January 8, 2020

Re: Comments on Draft Supplemental Environmental Impact Statement for Soil Cleanup Activities at Santa Susana Field Laboratory

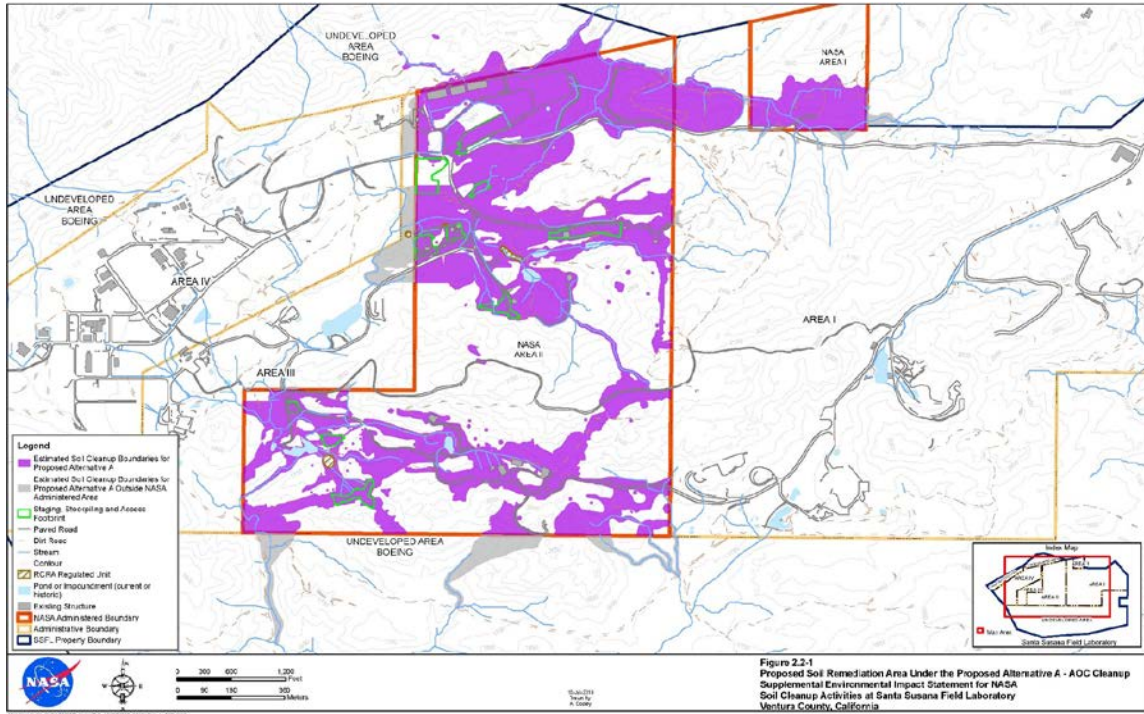
By NASA’s estimates, Alternative B would leave 56% of the contaminated soil by volume and 65% by acreage not cleaned up; Alternative C would abandon 72% by volume and 84% by acreage; and Alternative D would walk away from remediating 80% of the contaminated soil volume and 88% of the contaminated acreage. (DSEIS Table ES-2).

The amount of contaminated soil that NASA now proposes to walk away from can be seen in maps prepared by NASA. The purple area in the map below shows how much soil NASA admits it contaminated in its parts of SSFL and that it promised to clean up:

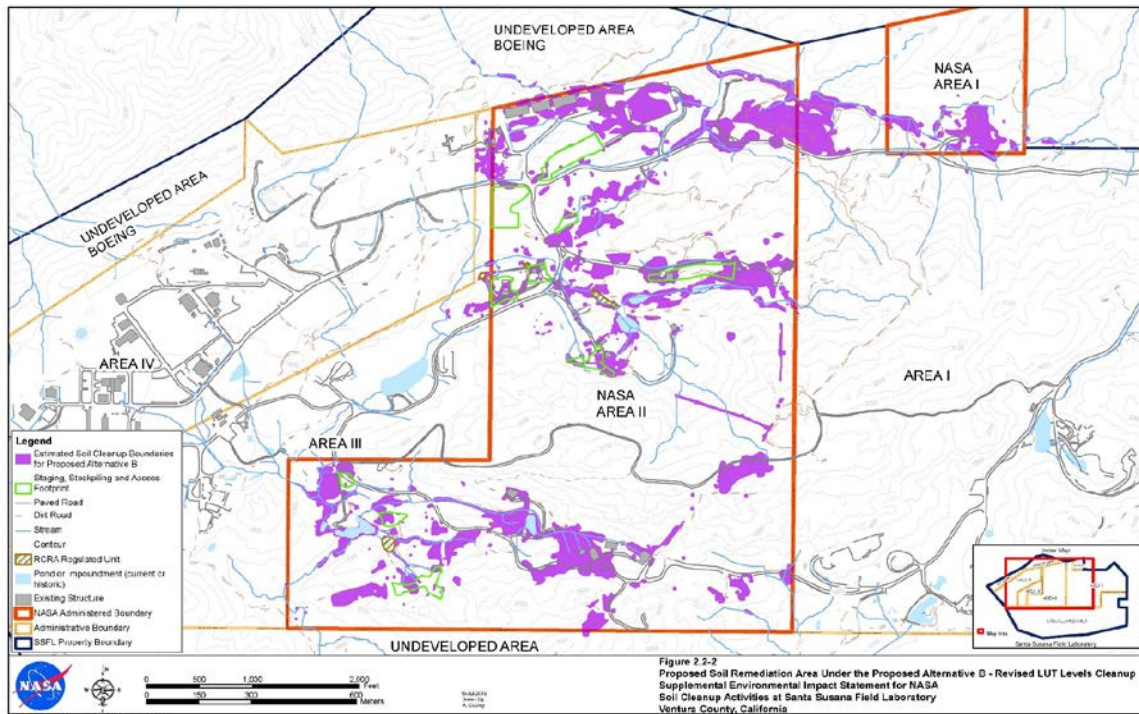
The next map shows how much would be cleaned up under its Alternative B:

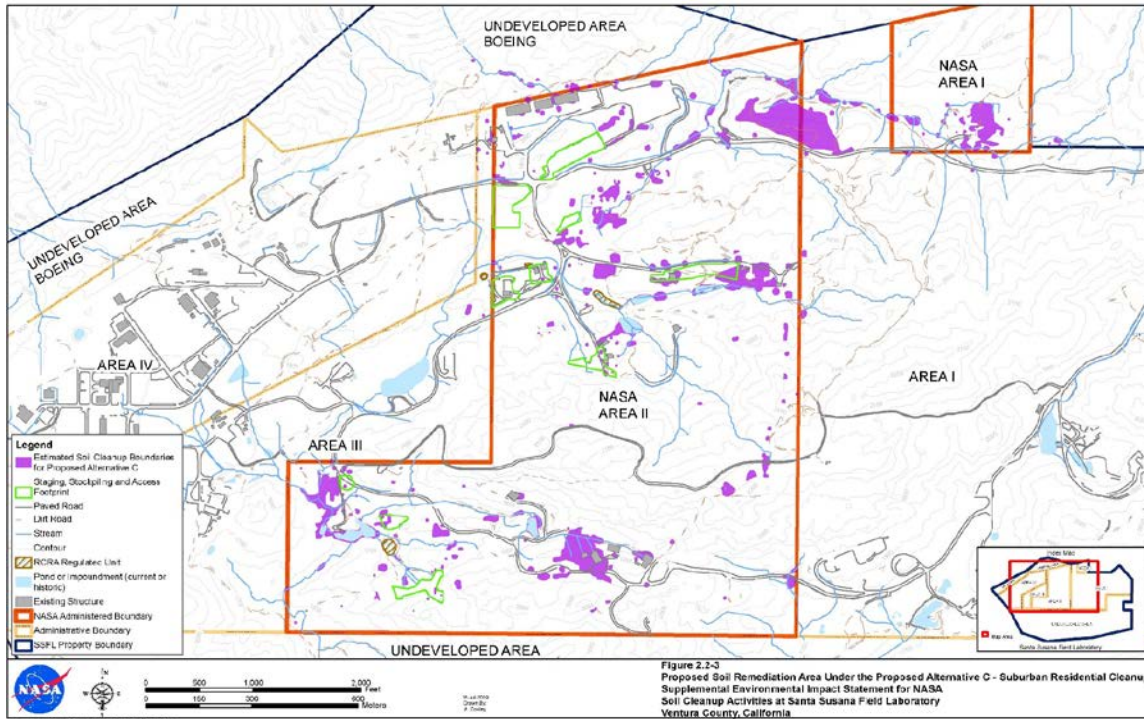
The next shows how much would be cleaned up under NASA's Alternative C:

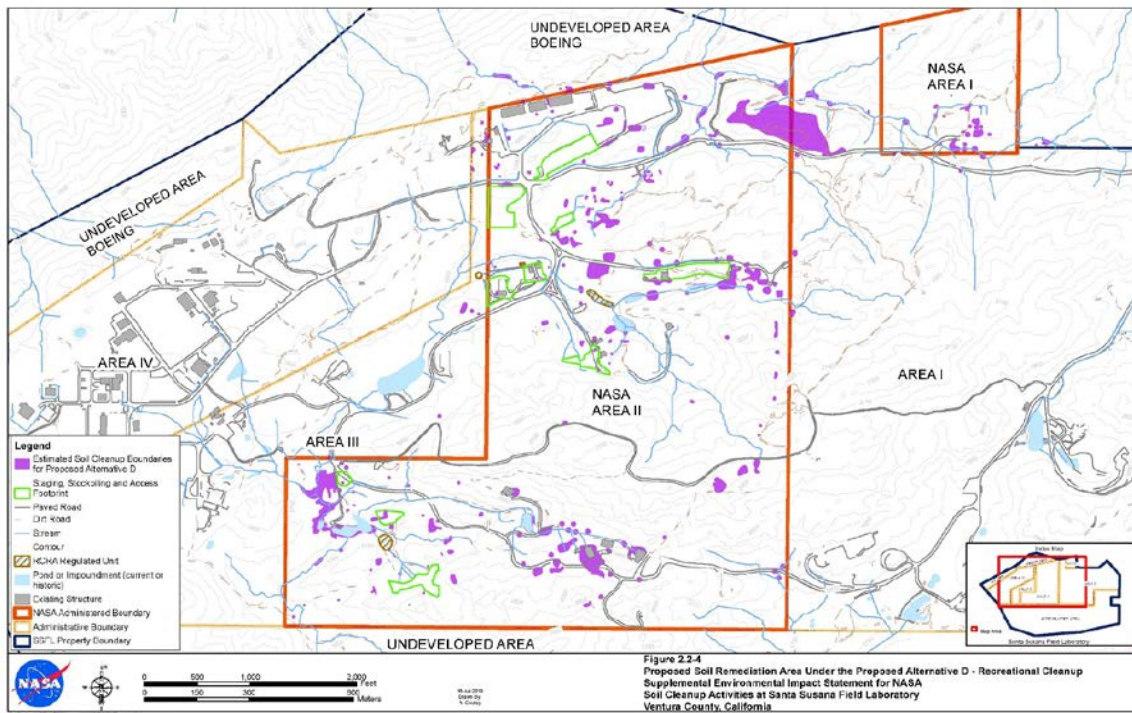
And the last option, Alternative D, would clean up only this amount:

**What NASA Promised (Alt. A)**

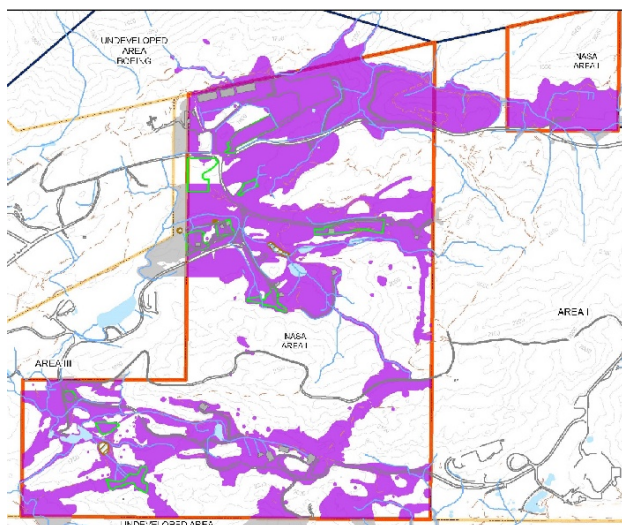
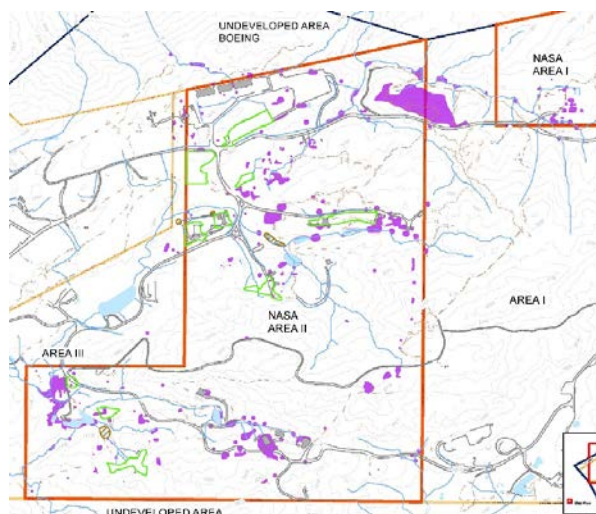
To understand the magnitude of the contamination NASA is proposing to walk away from, compare what it promised and is legally bound to do (Alternative A, the AOC) and what it now is contemplating (Alternative D):
